Revisions and Errata List
AISC Steel Design Guide 39, 1st Edition, 1st printing (Printed Copy)
November 25, 2024

The following list represents corrections made to the first printing (dated 2023) of the first edition of AISC Design Guide 39, *End-Plate Moment Connections*.

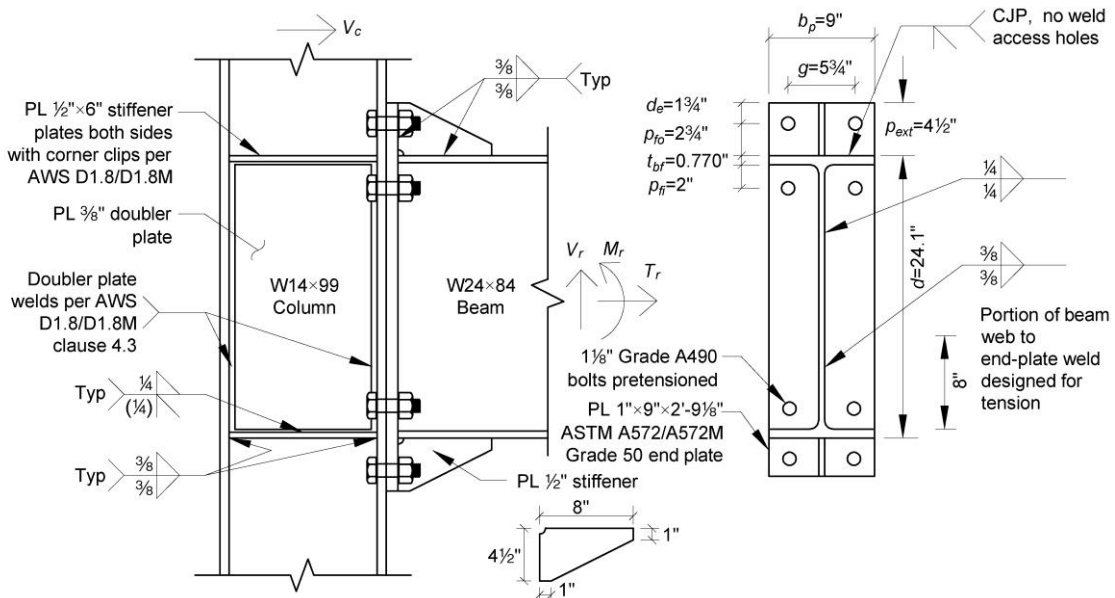
Page(s)	Item
vi	The page number for Example 5.3-3 should be revised to 153. The page number for Example 5.3-6 should be revised to 174.
121	The yield-line mechanism figure in Table 5-18 includes two erroneous yield lines and should be revised to:
